Access Compliance Report

Public Rights-of-Way

Intersection ID: 30341	Main Street: DULIN_CREEK_BV	Cross Street: GOLD_PAN_RD	Location: NW
ADA ID: F97C423817A7	Ramp Type: PerpDiag	Initial Pass/Fail: Fail	Overall Compliance: No
Severity Score: 8.75			
Codes/Mitigation Info/Possible Solution		Field Measurements/Component Compliance

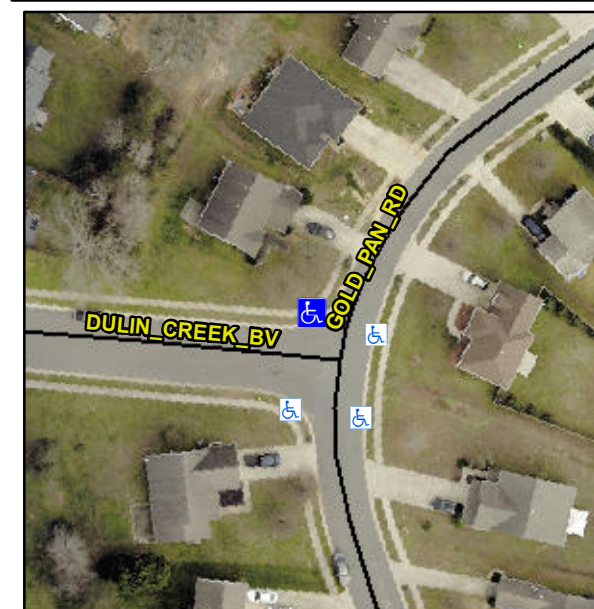
Not Found, R304.5.1

Compliance	Description	Data	Compliance	Description	Data
N/A	Ramp Length (in)	44.0	Yes	Ramp Slope (%)	5.3
No	Ramp Width (in)	45.5	Yes	Ramp XSlope (%)	1.4
N/A	Flare Type LT	N/A	N/A	Flare Type RT	N/A
N/A	Flare Slope LT (%)	N/A	N/A	Flare Slope RT (%)	N/A
N/A	Flare Traversable LT?	N/A	N/A	Flare Traversable RT?	N/A
N/A	Landing Length (in)	N/A	N/A	DWS Provided?	N/A
N/A	Landing Width (in)	N/A	N/A	DWS Contrast?	N/A
N/A	Landing Slope (%)	N/A	N/A	DWS Length (in)	N/A
N/A	Landing X Slope (%)	N/A	N/A	DWS Full Width?	N/A
N/A	Landing Curb? (Y/N)	N/A	N/A	DWS Offset (in)	N/A
N/A	Shared Landing?	N/A			
N/A	Gutter Ponding?	N/A	N/A	Gutter Slope (%)	N/A
N/A	Gutter Lip Ht (in)	N/A	N/A	Gutter X Slope (%)	N/A
N/A	Painted X Walk1?	No	N/A	Painted X Walk2?	No
	X Walk 1 Direction	To S		X Walk 2 Direction	To E
N/A	X Walk 1 Width (in)	N/A	N/A	X Walk 2 Width (in)	N/A
	X Walk 1 Slope (%)	3.1		X Walk 2 Slope (%)	2.8
	X Walk 1 X Slope (%)	2.0		X Walk 2 X Slope (%)	1.9

Remove & Replace Curb Ramp With Two New Directional Ramps or Equivalent.
